Notice of Decision

Water Pollution Control Permit
Number NEV2007105

Firstgold Corporation

Relief Canyon #2

Charts of Analysis Results for MW-05-1: Al, As, Fe, Mn
(Comment 5)

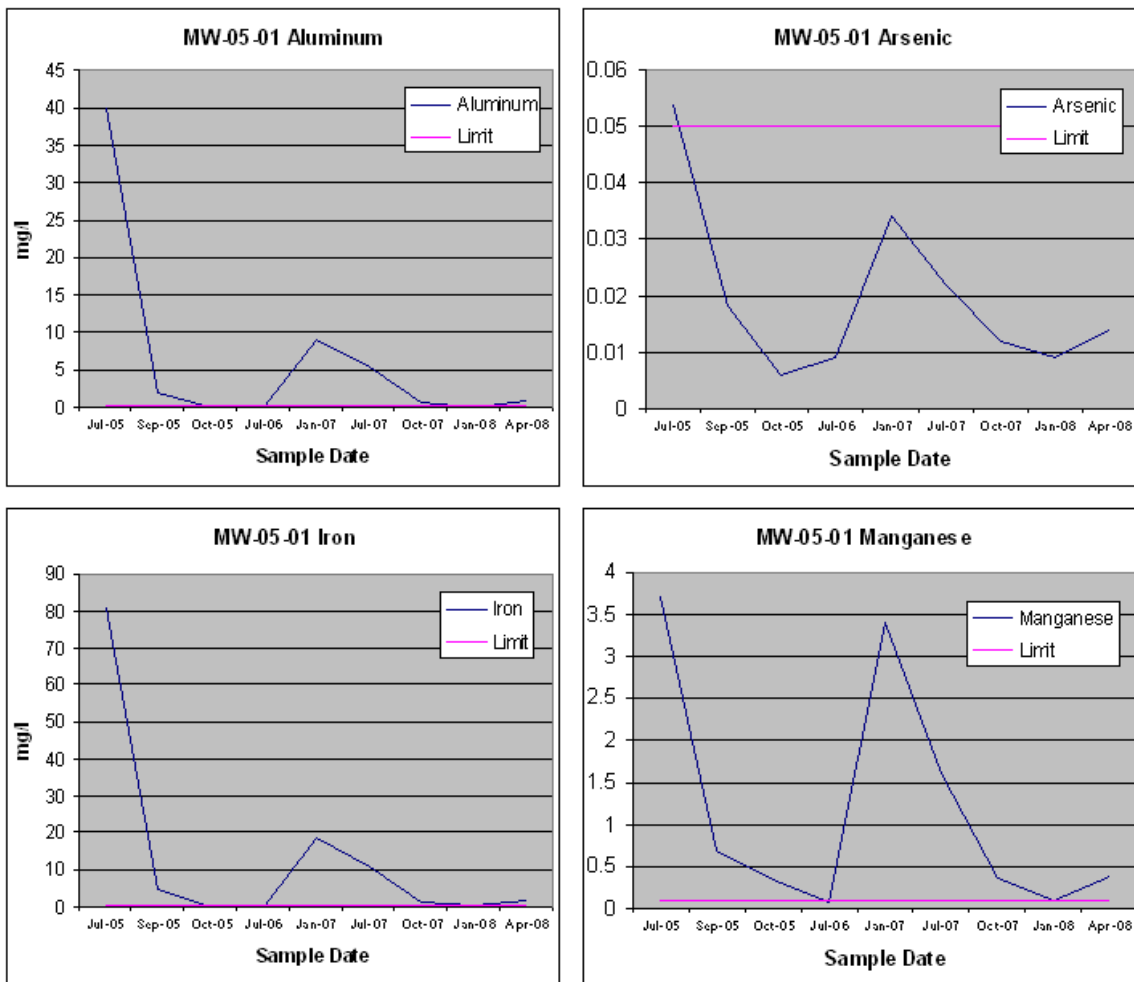
Comment 5: "Based on the chemistry observed at MW-05-1, some constituents have unnaturally high concentrations. These include iron, manganese, nickel, thallium and aluminum; arsenic also had one exceedance. The variability of these constituents with time, shown in Table 2 of the application, demonstrates there is an ephemeral or seasonal source."

Response: *First, a clarification. Table 3 on page 12 of the application document contains several typographical errors in the column for July 2005 which have since been corrected after checking the lab reports for this analysis. Among the corrections are the values for nickel, which was 0.072 mg/l (shown erroneously as 0.27 mg/l), and for thallium <0.001 mg/l (shown erroneously as 0.2 mg/l). With these revised values, there is no exceedance for either nickel or thallium.*

Second, it has recently been determined that Permittee has been submitting unfiltered water samples to a Nevada certified laboratory for analysis. The presence of suspended solids may have resulted in elevated constituent concentrations (the Profile I limits are based on dissolved constituents only). Permittee has also encountered difficulty in purging well MW-05-1 to obtain representative samples. These two factors may have contributed to sample variability.

The charts below show the history of sampling for all 9 analyses conducted for MW-05-1. The high degree of variability between the samples is clearly evident. These fluctuations do not match any observed variability in heap draindown volume or chemistry, nor do they contain any tracer constituent to indicate that they are related to process solution, which has not been applied to the site for a number of years.

Permittee has agreed to develop a sampling procedure to resolve these issues. The Division will be monitoring the results of upcoming sample analyses to verify that the issue has been properly addressed. In addition, and as noted in the Division response to Comment 3 above, an additional well will be added upgradient of the site to establish background water quality more definitively.
